Lida Textile & Dyeing Limited- Extended Buildings- new unit

Buildings Information

Observations

Ground floor columns are susceptible to long column effect

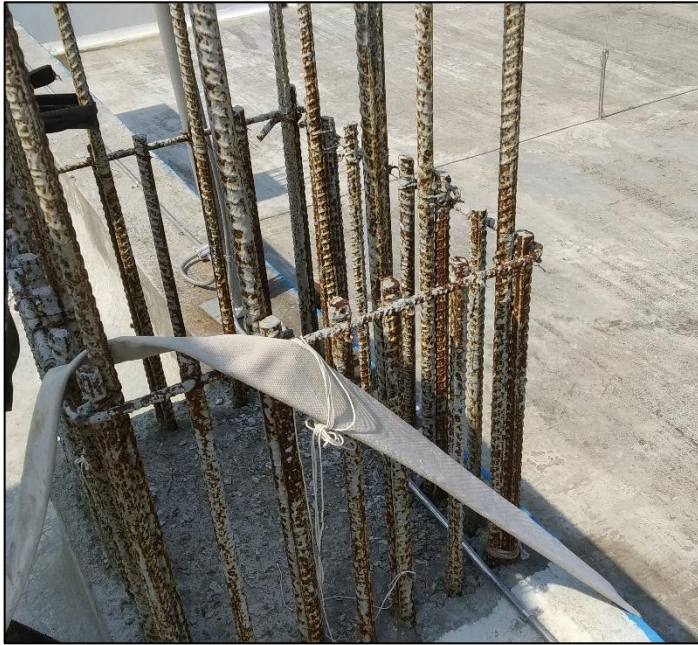
Ground floor column are 27 feet in dimension (length), marking the possibility of slenderness effect. Only the columns are carrying the total suspended loads. Factory is required to address these issues in the design report.

Exposed rebar at roof prone to corrosion

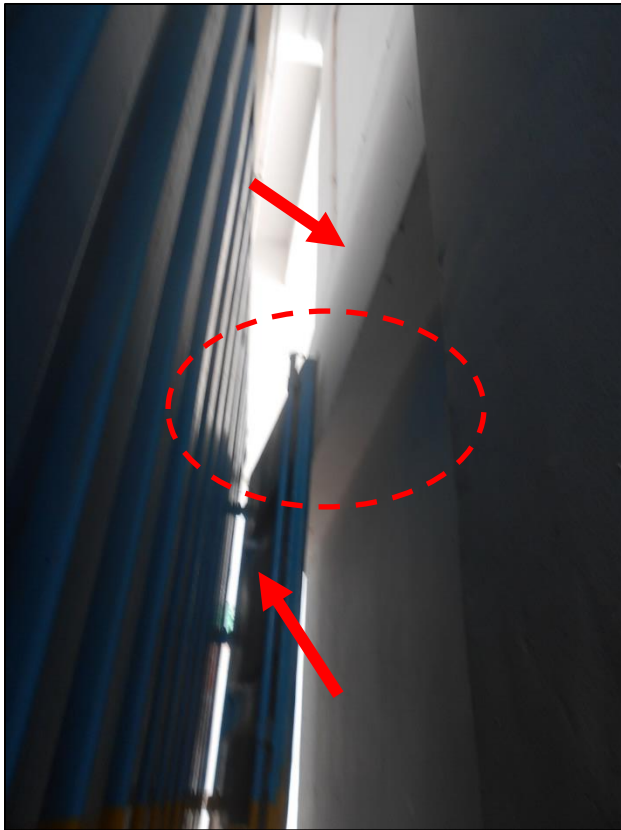
Exposed rebar was found at roof where the overhead water tank supposed to be constructed. The factory engineer is required to take necessary measures to prevent the corrosion in exposed re-bar.

Structural members susceptible to vehicular impact

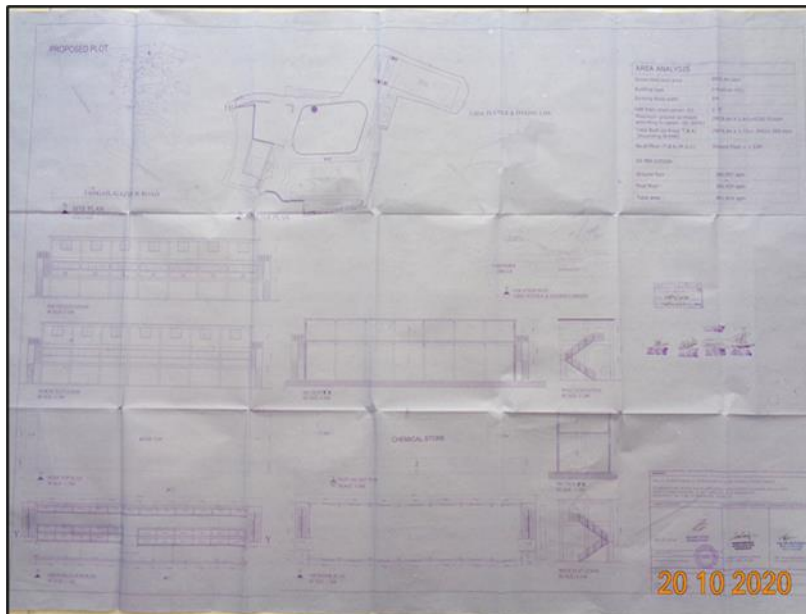
Ground floor stair beam is being impacted by the truck door

Insufficient column guard on ground floor exterior column only

Sign of impact on ground floor internal column

Structural members were found adjacent to the driveway of loading-unloading platform. These column are susceptible to vehicle impact. The factory engineer is required to take necessary measures to prevent the vehicle impact by providing the barrier around the structural members.

Lack of as built drawings

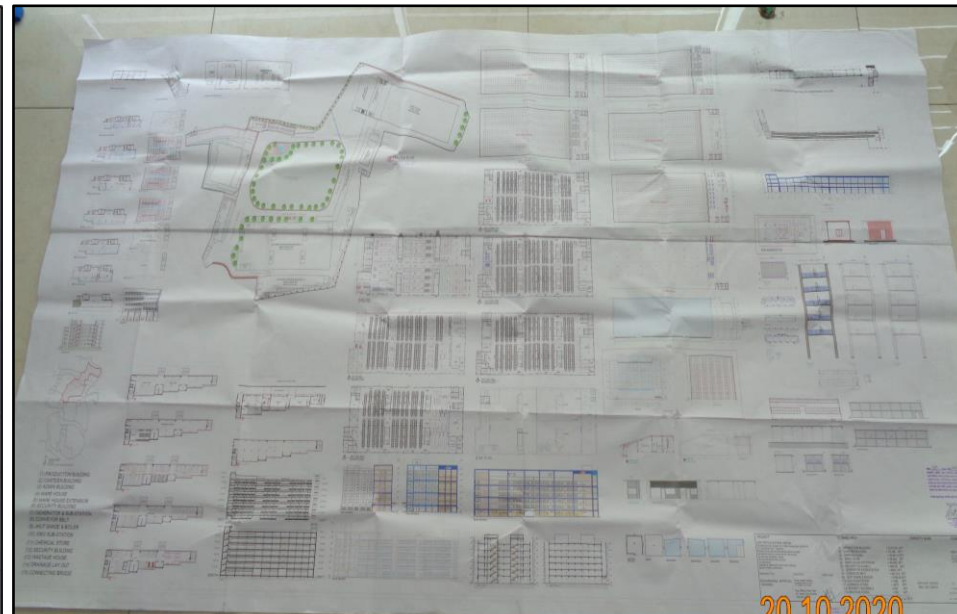
There were no credible as-built drawings and documents to review except permit drawing from Pourashava and Industrial layout from DIFE. Provided drawings were insufficient to represent the as-built structures. Factory engineer is required to survey the structures and prepare as-built drawings that are in compliance with section 1.9.1.2 as per BNBC.

Susceptible to Trolley impact in column

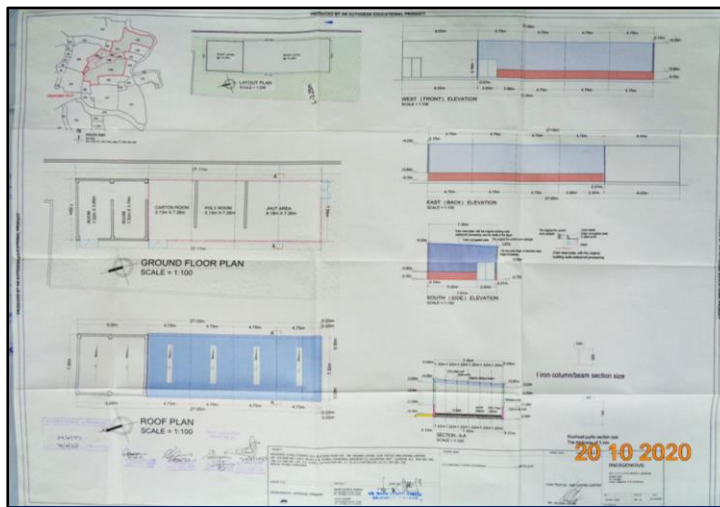
Column damaged due to trolley impact

Column adjacent to aisle was found damaged due to impact from trolley. The factory engineer is required to take necessary measures to repair the damage and to prevent the trolley impact by providing the barrier around the column.

Lack of as-built drawings

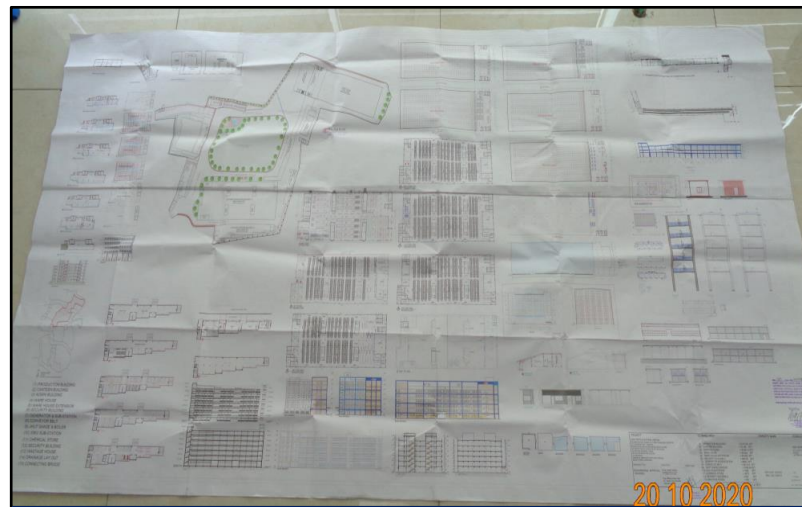
There were no credible as-built drawings and documents to review except permit drawing from Pourashava and Industrial layout from DIFE. Provided drawings were insufficient to represent the as-built structures. Factory engineer is required to survey the structures and prepare as-built drawings that are in compliance with section 1.9.1.2 as per BNBC.
